August 1, 2025

PROJECT NAME: CHITOLIE ENTERPRISES LLC

PROJECT NUMBER: 2025060060

APPLICATION: MINOR SITE PLAN #32992

LANDSCAPE PLAN  
SCALE: 1" = 20'

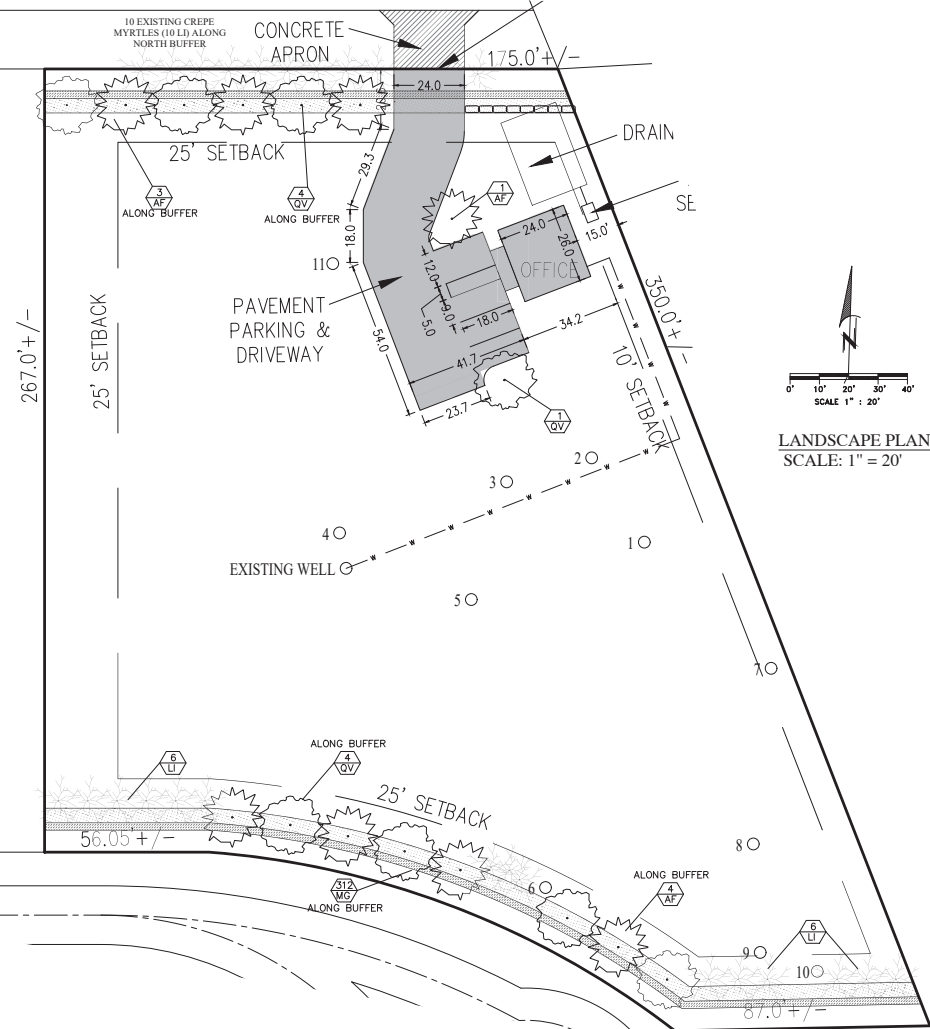
REMARKS: Indicate tree removals on plan - plans show 20", which tree is this?

- 24 DEPARTMENT: LSCAPE - LANDSCAPE DESIGN AND IRRIGATION  
REVIEW ITEM: 6.8.4 - Landscape area requirements for non-residential development  
STATUS OF REVIEW: NO  
REMARKS: Information missing from calculation - plans show xxxxx sf

- 25 DEPARTMENT: LSCAPE - LANDSCAPE DESIGN AND IRRIGATION  
REVIEW ITEM: 6.8.6 - Buffers  
STATUS OF REVIEW: NO  
REMARKS: 1. West buffer is a B type (commercial to residential), will require a 20' buffer with a wall. 2. East buffer requires C type Buffer 3. Crepe myrtles are deciduous and will not meet intent of year round screening, please use evergreen ornamentals for majority of requirement to meet screening intent

- 26 DEPARTMENT: LSCAPE - LANDSCAPE DESIGN AND IRRIGATION  
REVIEW ITEM: 6.8.7 - Parking areas and vehicular use areas  
STATUS OF REVIEW: NO  
REMARKS: Parking terminus island shall be landscaped - site is within primary Springs Protection Zone

- 27 DEPARTMENT: LSCAPE - LANDSCAPE DESIGN AND IRRIGATION  
REVIEW ITEM: 6.8.8 - Building landscaping  
STATUS OF REVIEW: NO  
REMARKS: 6.8.8. Landscape areas shall be provided adjacent to or within 25 feet from the building walls and shall extend along 60 percent of the total length of the wall, excluding those areas required for access to the building. Landscape areas shall be a minimum of five feet wide allowing for a minimum distance of two feet from the façade to the innermost plants.

IRRIGATION PLAN:  
SCALE: 1" = 40'

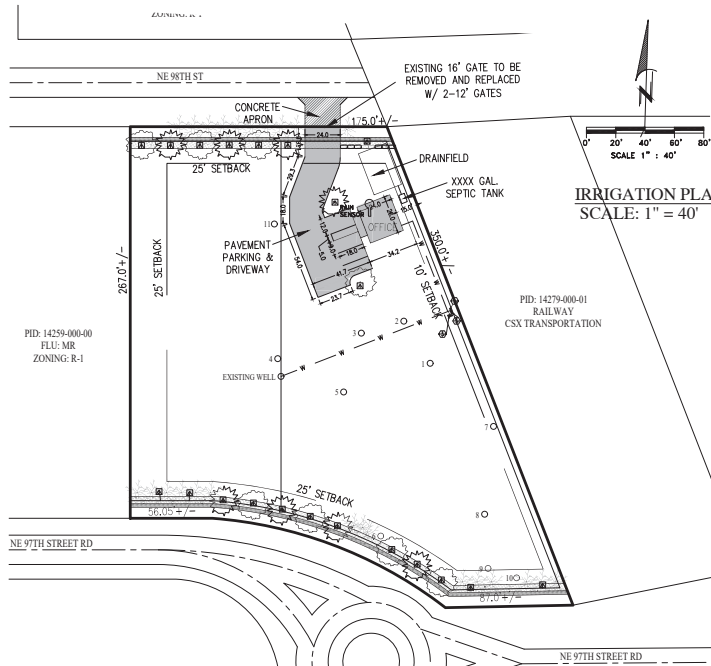
- 30 DEPARTMENT: LSCAPE - LANDSCAPE DESIGN AND IRRIGATION  
REVIEW ITEM: 6.9.2 - Irrigation plan requirements (details, legend, notes)  
STATUS OF REVIEW: NO  
REMARKS: Irrigation plan does not show irrigation to required west buffer or east buffer areas
